SERVICE BULLETIN

Classification: RA17-004	Reference: NTB17-107	Date: September 26, 2017
-----------------------------	-------------------------	-----------------------------

2016-2017 MAXIMA AND ALTIMA; POP/CLUNK NOISE FROM REAR WHEN DRIVING OVER BUMPS

APPLIED VEHICLES: 2016 – 2017 Altima (L33) **SR Only**
2016 – 2017 Maxima (A36)

Figure 1

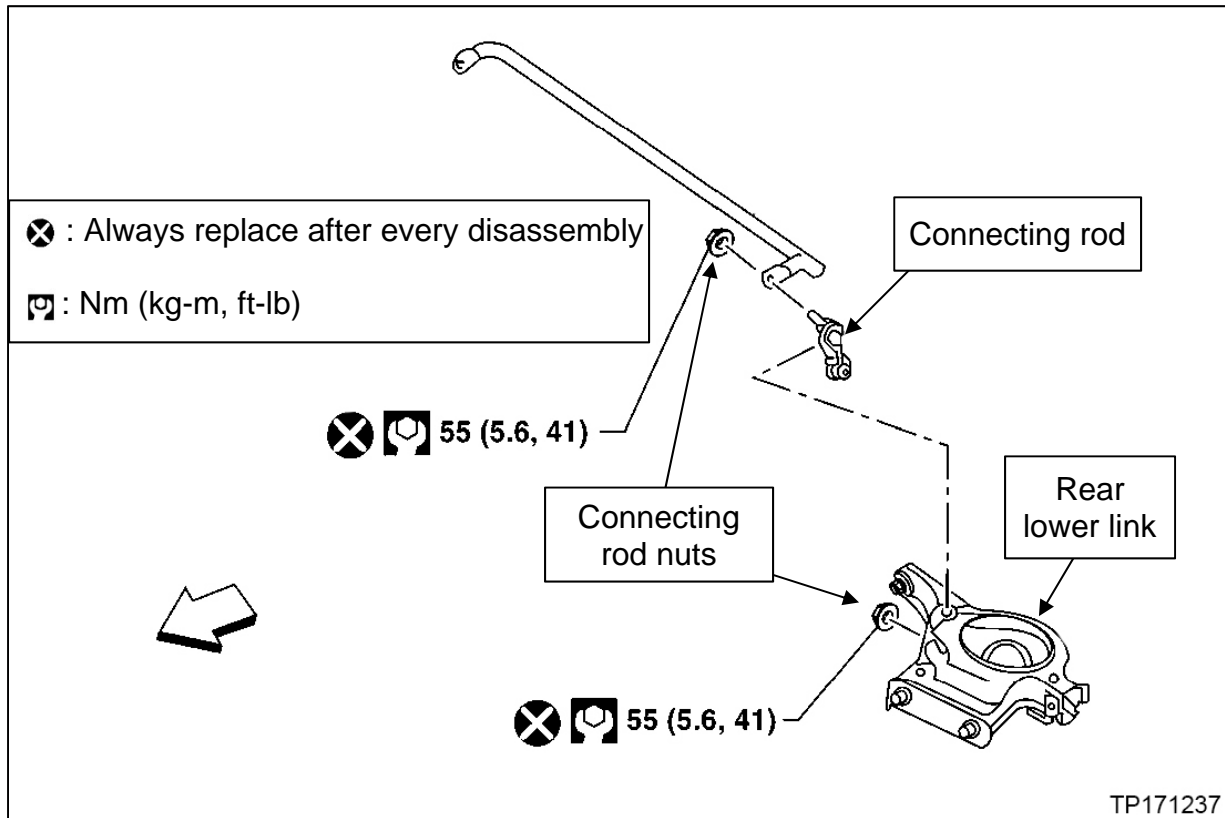
The rear suspension connecting rod nuts are found to be loose on the left and/or right side.

Replace the connecting rod and nuts on the left and/or right side with the ones listed in Parts Information.

1. Remove the connecting rod nuts on the affected side.
2. Remove the connecting rod.
3. Install the new connecting rod and nuts.
 - New connecting rods and nuts are listed in the Parts Information.
